Proposed Development: Demolition and construction of a new dwelling house and alterations to existing garage and landscaping.

### At: 1156 BARRENJOEY ROAD PALM BEACH NSW 2108

## **Comments in Response to Plans for Proposed Development**

DA No: N0022/16

1501-P-00 rev.B

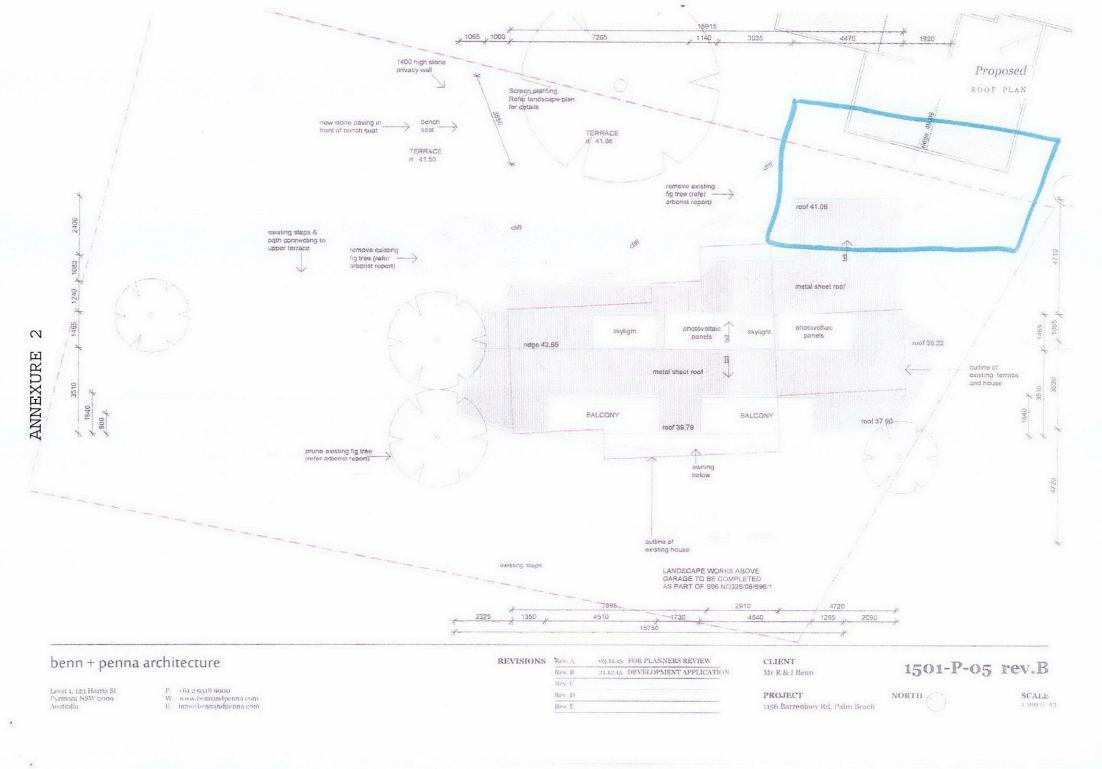
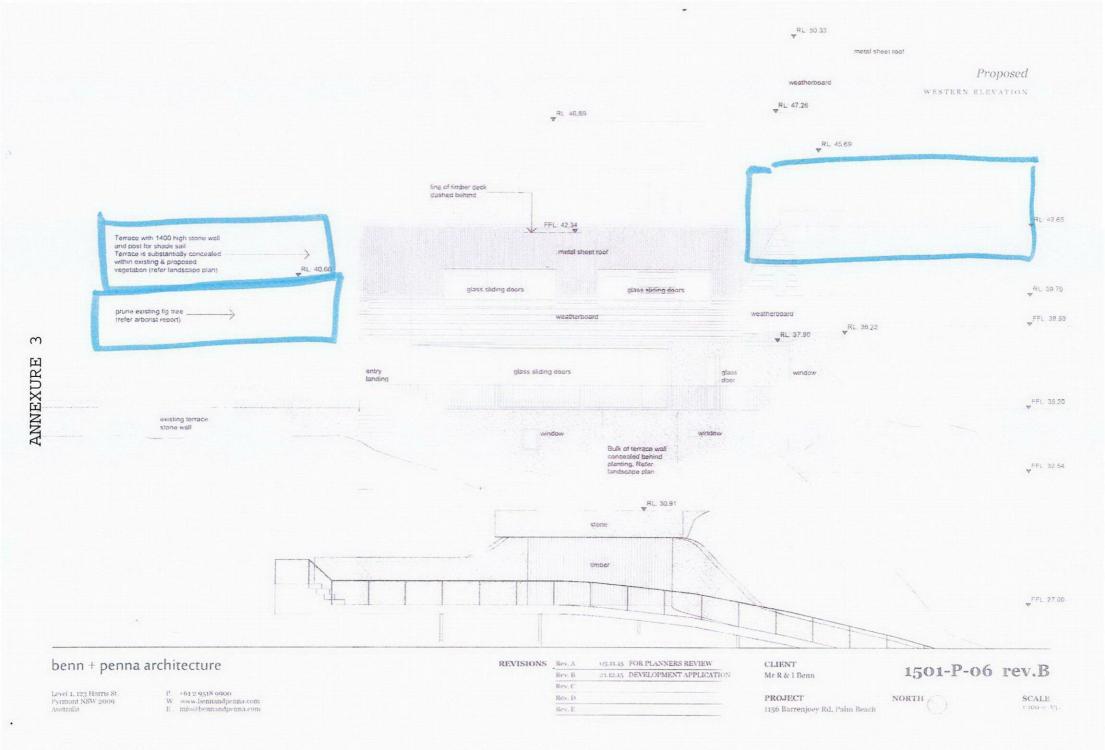
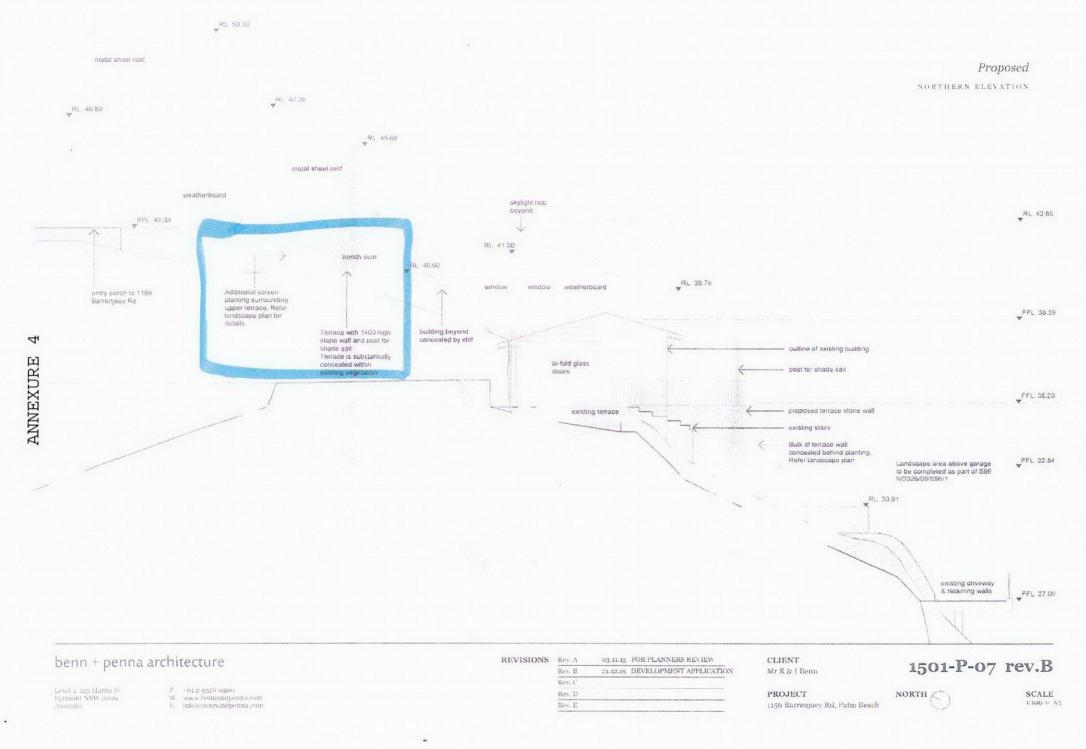
- 3. I request further information on the first floor rear steps and landing, access to the upper terrace, upper terrace, curved wall, curved seating, paved terrace, shade sail and associated removal of plants and proposed planting shown in the plans for the area above the existing cliffs. I have annexed five pages from the plans with the relevant aspect of the proposed development highlighted.

- 4. On the information provided in the plans, I cannot understand exactly how the upper terrace will be accessed and where the wall, seating and terrace would be located. It is unclear on the plans. On the basis of our interpretation of the plans, this aspect of the development is likely to have the greatest negative impact on our property and the ecological value of the wildlife corridor.

SOUTHERN ELEVATION

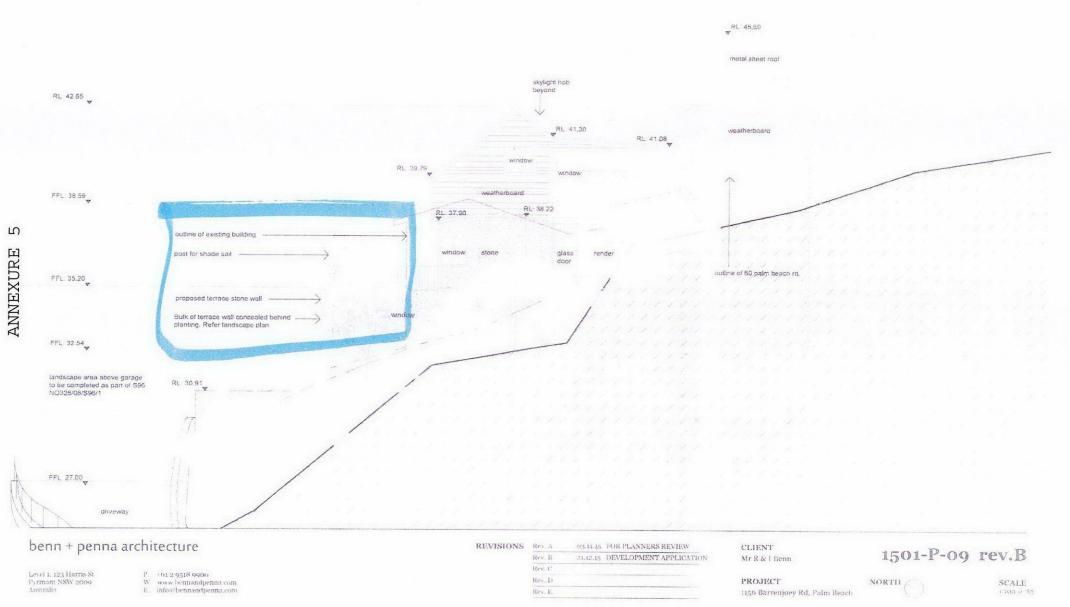
- 15. It is also likely that the view from the lower western section of our dwelling will be substantially blocked, much more than the elevations provided initially suggest. Comparing the plan 1501-P-05 rev B (Annexure 2) with 1501-P-06 rev B (Annexure 3), it is possible to see that the roofline of the proposed dwelling will, in fact, extend almost to the ridge line of the lower western section of our house. This would block half of the windows at this level for greater than half their height. I object to the proposed roof height on this basis.
